10855-NI-E21-1030-2 (1)-3 REV. 61C

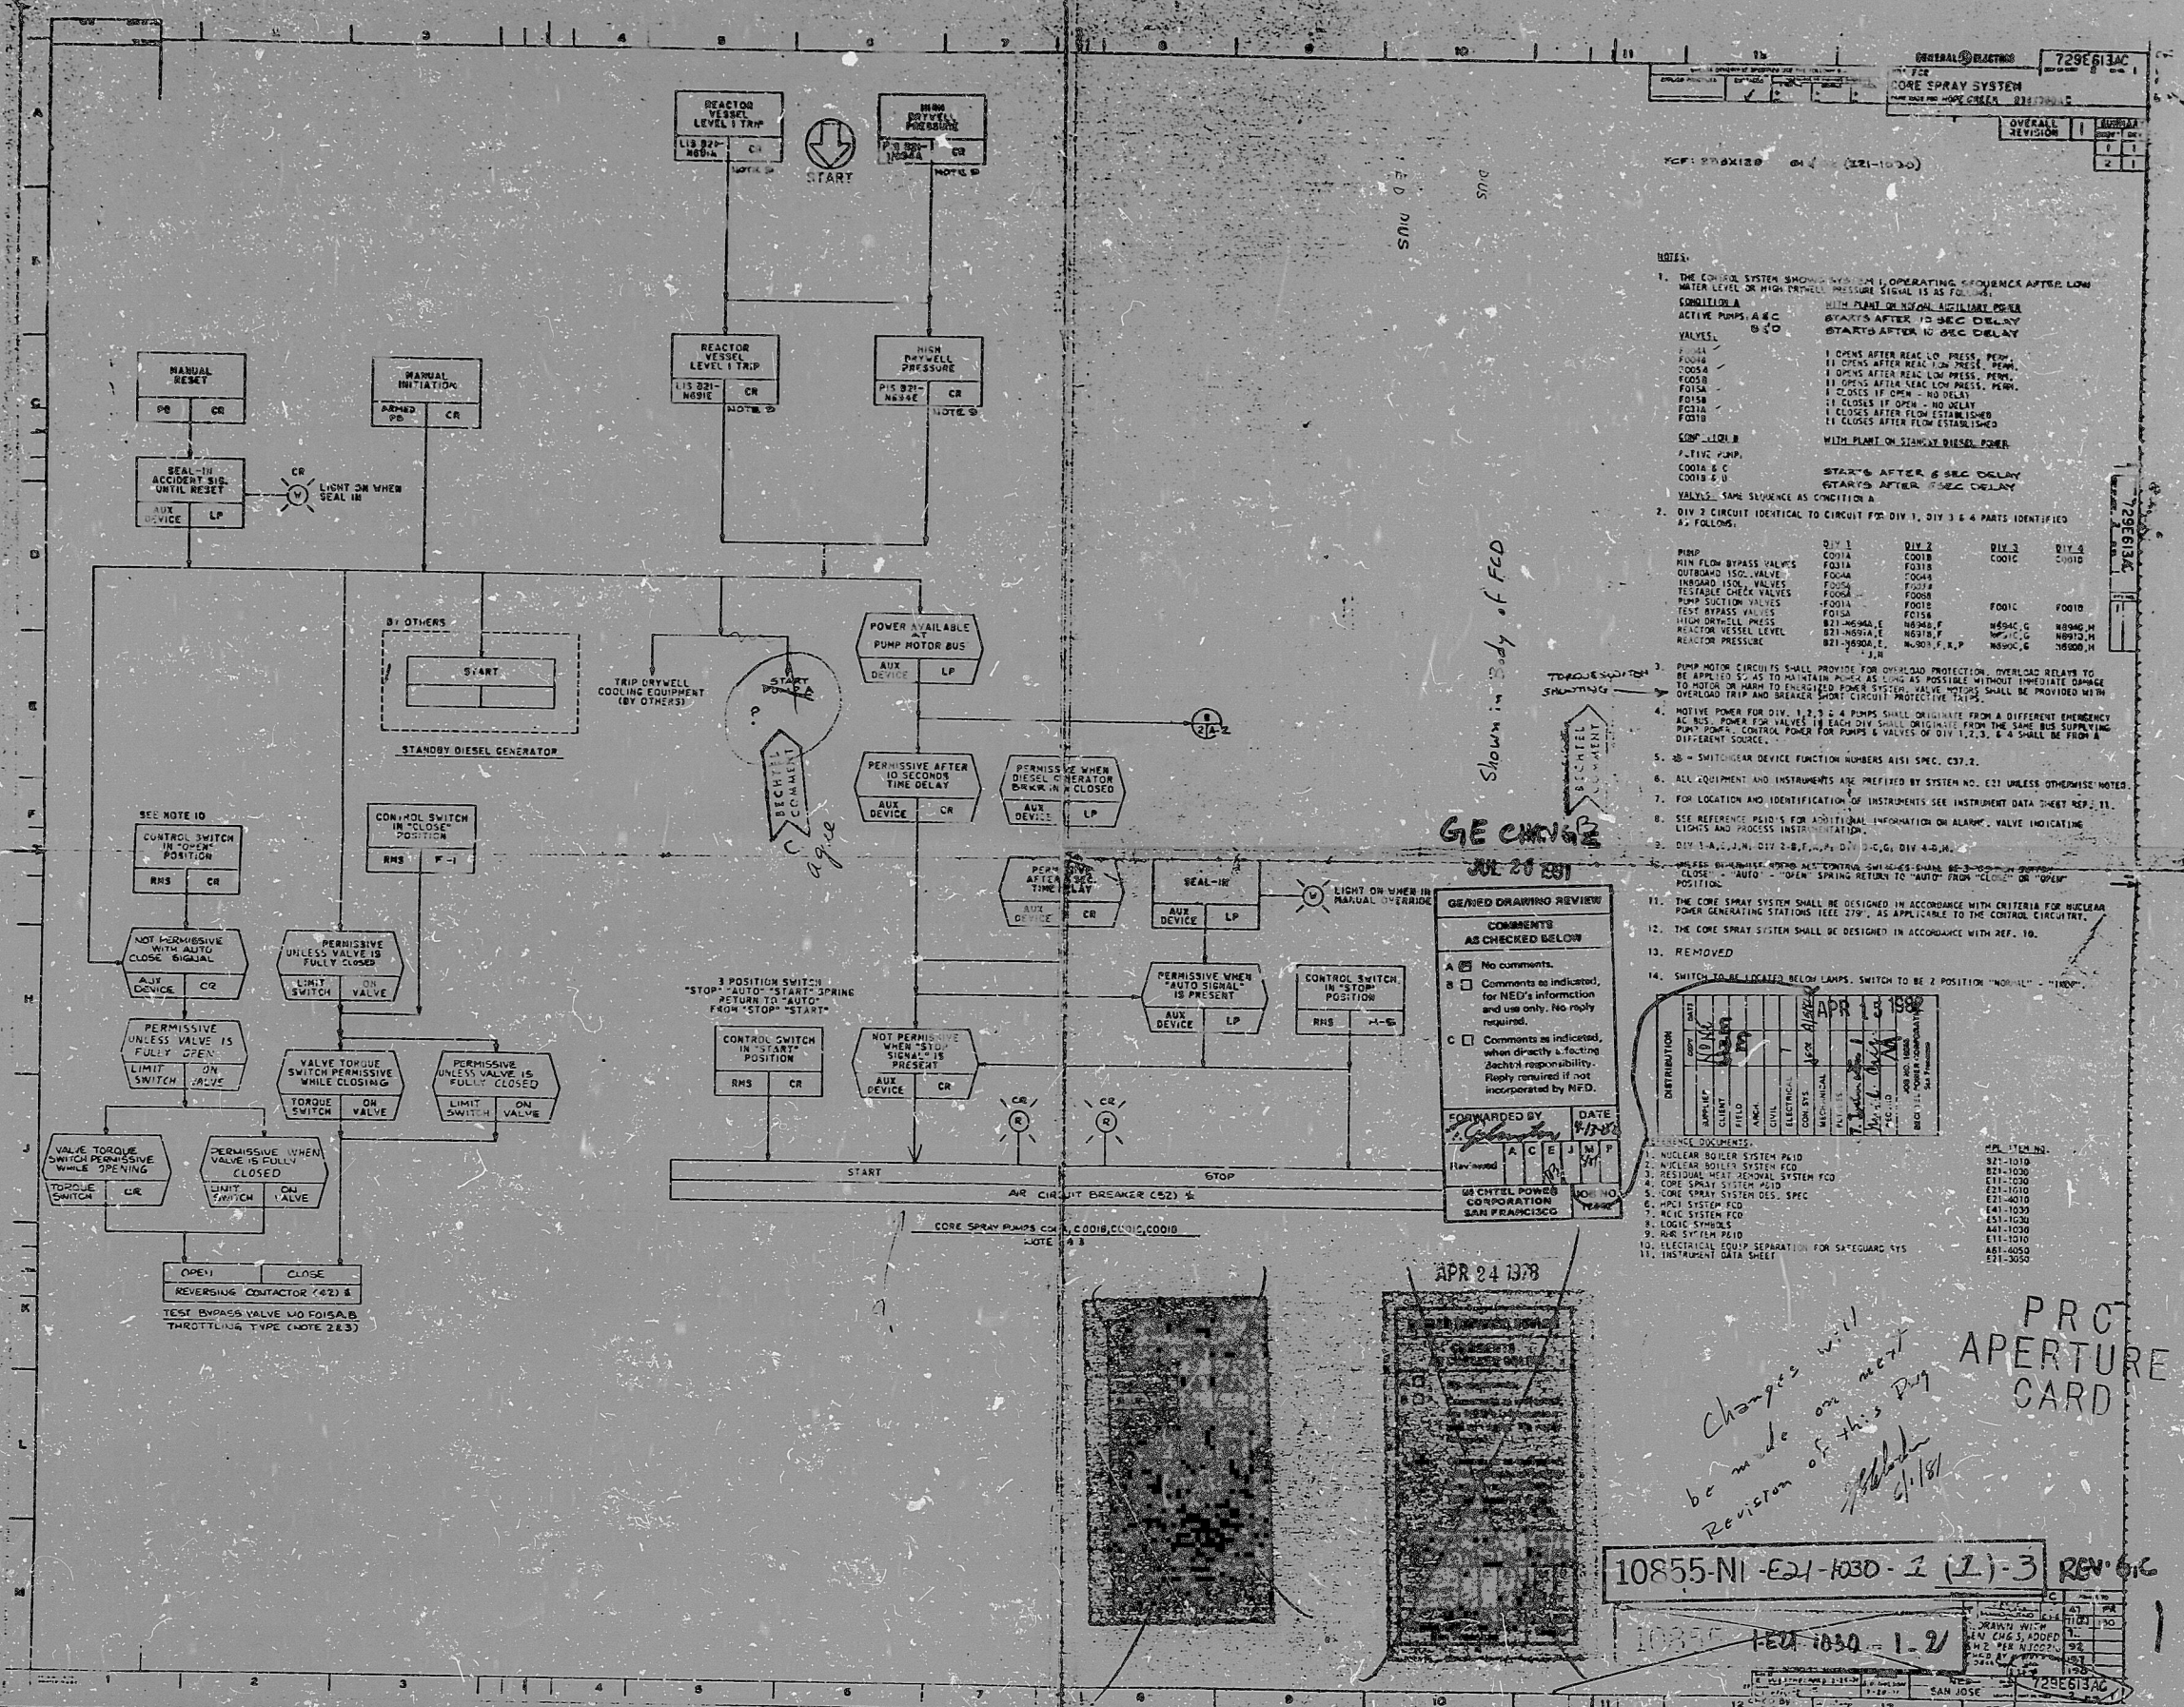
Changes will
be made on next
Revision of this Proj
J. J. [Signature]
9/18/81
